LTE Cat-M1 Cellular Pmod™ Expansion Board
for RYZ014A
Errata

Renesas LTE Cat-M1 Cellular IoT Modules

This Errata describes the known issues and exceptions to the functional specifications for the RYZ014A Pmod Expansion Board.

Figure 1. RTS0 Pull-up Resistor R1

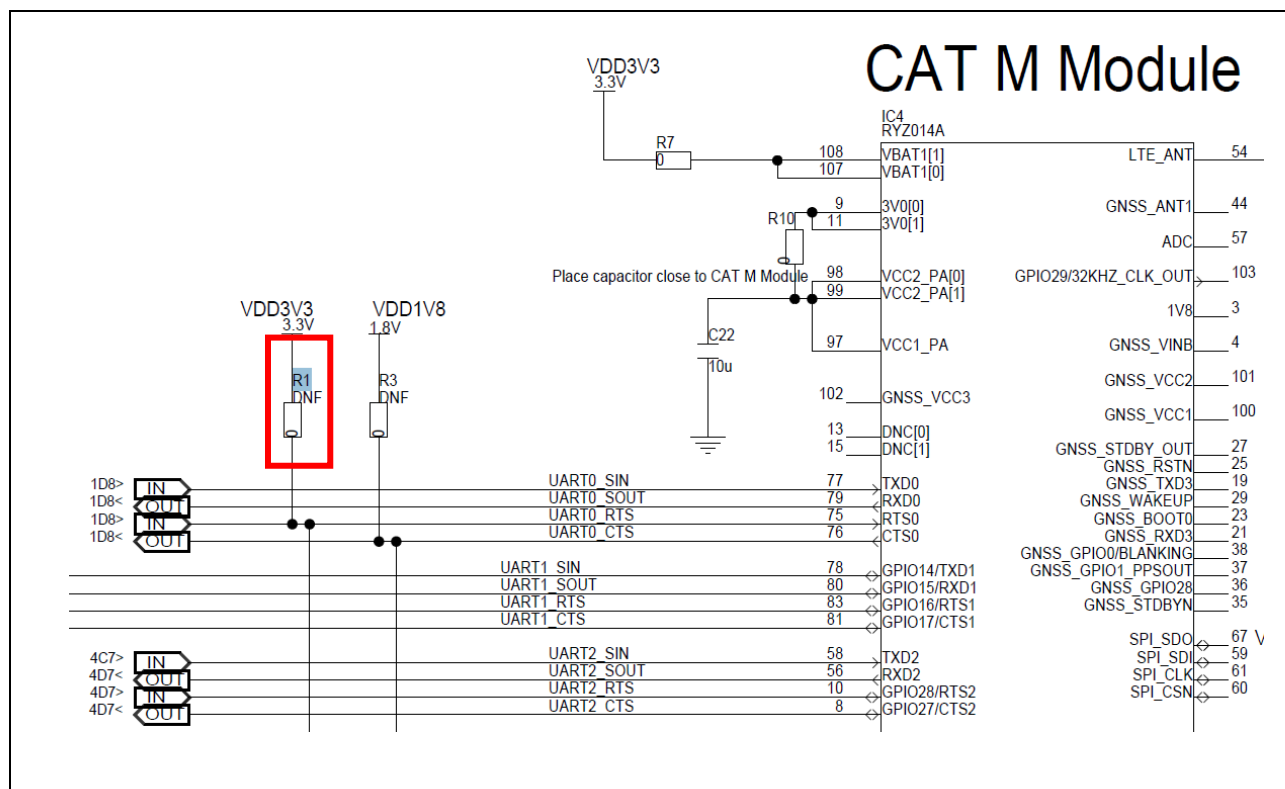
The RTS0 signal (pin 75) of the RYZ014A module should be pulled up to VDD1V8. On the schematic and board the 0R pull-up resistor R1 (DNF) is connected to VDD3V3.

In your own design implementation, ensure that the RTS0 signal is pulled up to 1.8 V if needed. Refer to the *RYZ014A Module Hardware Manual* and *RYZ014A Module Integration Guide* for more details – see resource links in section 3.
